# TDECQ for 400GASE-DR4: proposed change to filter response.

Marco Mazzini/David Siadat – CISCO

## 124.8.5 Transmitter and dispersion eye closure for PAM4 (TDECQ)

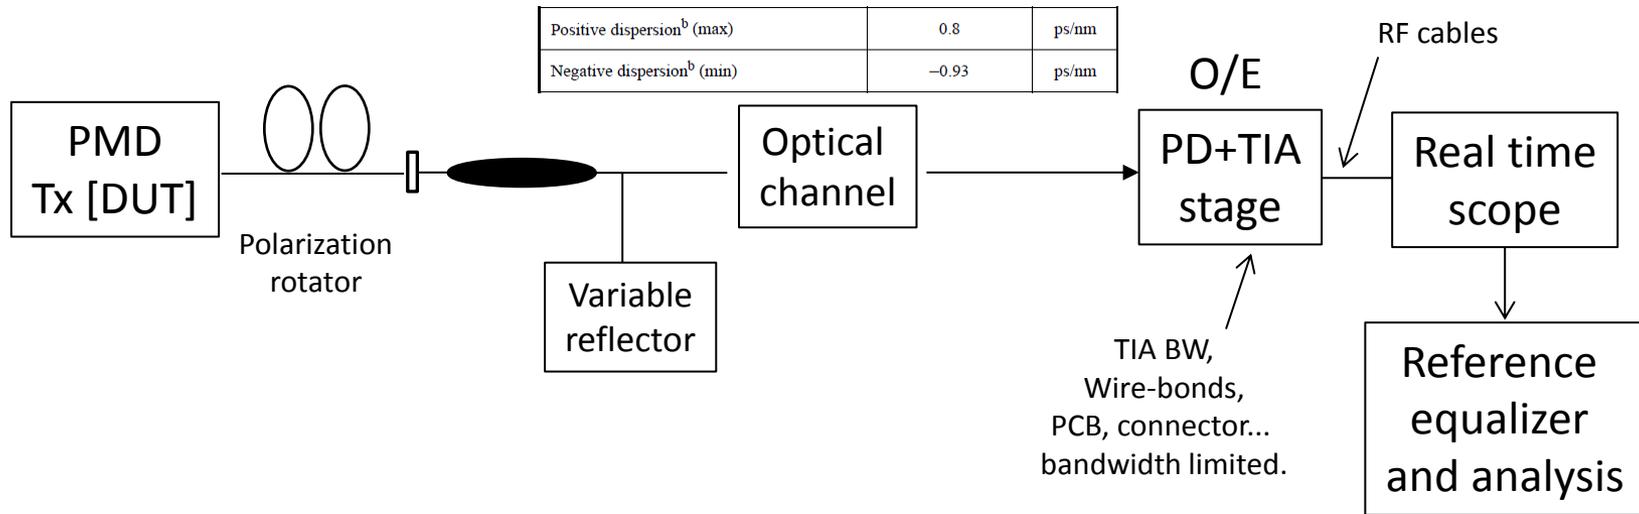
- Implementing TDECQ conformance test set-up with real-time scope can limit the bandwidth because an external O/E is needed.
- Simulation of optimized solutions show a 3dB bandwidth of 34.25GHz, without including cables and connectors losses.
- For this, the value of combination of the O/E converter and the oscilloscope filter response bandwidth of draft 1.4, 124.8.5 should be reduced to take into account real-time implementation.
- From first analysis and available hardware, seems a reasonable minimum value closer to 33GHz rather than 38.68GHz.
- One side advantage is that this will allow (also) to test TDECQ with receiver filter closer to what real system would be, allowing to remove it on higher bandwidth TDECQ set-up implementation too.

From above, into **124.8.5**, we then propose to change:

*“The combination of the O/E converter and the oscilloscope has a fourth-order Bessel-Thomson filter response with a bandwidth of 38.68 GHz”.*

*“The combination of the O/E converter and the oscilloscope has a fourth-order Bessel-Thomson filter response with a **minimum** bandwidth of **33** GHz”.*

# Insertion Loss performance differences.

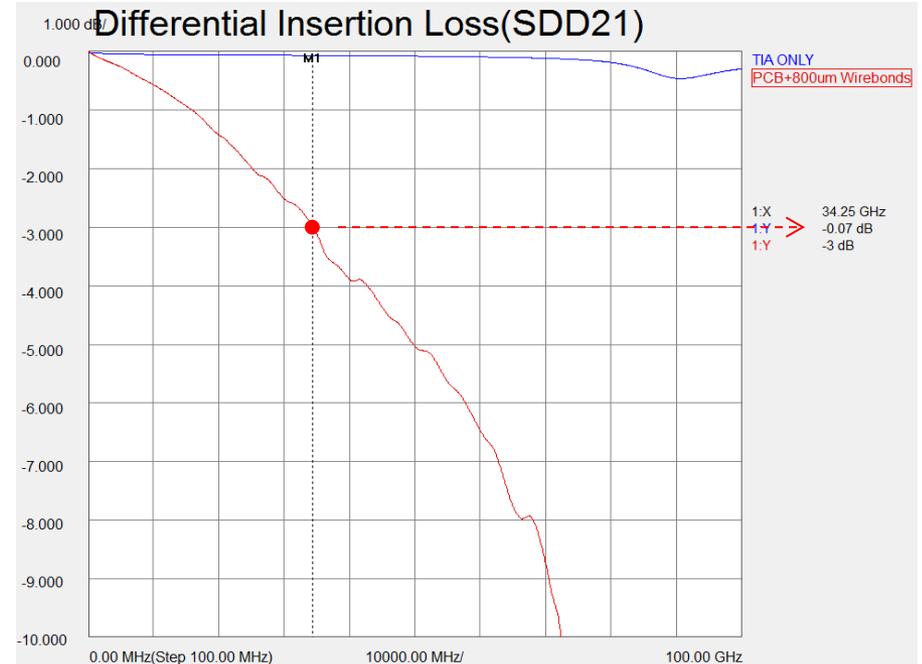
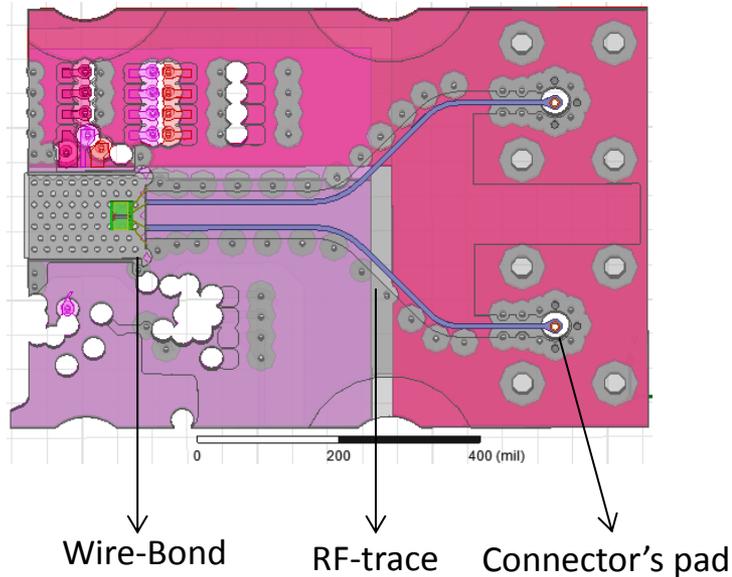
Left picture is a typical design of a discrete PD+TIA stage, followed by wire-bonds to PCB and connector pad.

Blue and red line is BW comparison between such cascade (red) and the achievable TIA bandwidth (blue): the limitation is not in the TIA itself, but in the channel following it.
